The Planning Commission agenda for **November 26, 2007** will include the following item for your consideration:

Simply Self Storage: A Site Development Plan, Landscape Plan, Tree Stand Delineation, Tree Preservation Plan, Lighting Plan and Architectural Elevations for a 2.31 acre parcel located east of the intersection of Long Road and Chesterfield Airport Road.

Stock and Associates, Inc. has submitted on behalf of OB Companies, A Site Development Plan, Landscape Plan, Tree Stand Delineation, Tree Preservation Plan, Lighting Plan and Architectural Elevations for the above referenced project. The Department of Planning and Public Works has reviewed this request and submits the following report.

1 NORTH ELEVATION - DUMPSTER SCREEN
1/8" = 1'-0"

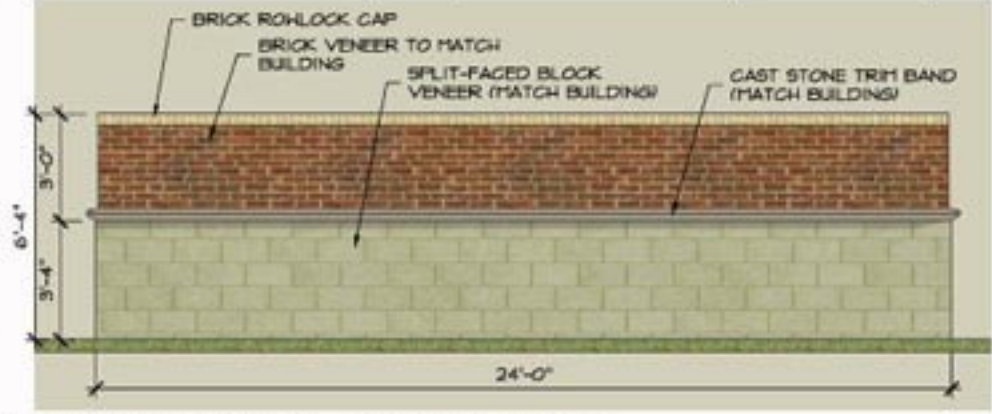
1. All rooftop HVAC units are to be screened so as not to be visible.
2. The trash enclosure should match the masonry pattern of the columns on the building.
3. The paneled areas on the eastern elevation should be revised to look the same as the paneled areas on the northern elevation.
4. Provide low screening in front of the parking area along Chesterfield Airport Road.

The petitioner has implemented all of the changes requested by the Architectural Review Board.
